Technical Service Bulletin No. 36

Created by: Lab.gruppen AB Service Department

Reference no: Missing support post

1	Do a visual check and see if the support post is mounted (see orange arrow)	
---	---	--

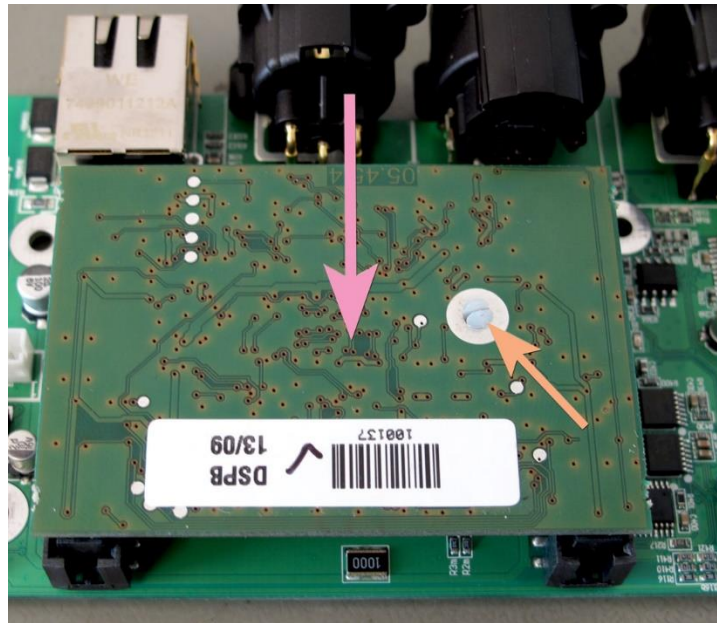
The DSPB board can jump out of its position from the ADIC-board, making a malfunction on the unit

Make a visual check to see if the support has been mounted.

Mount the support if it is missing
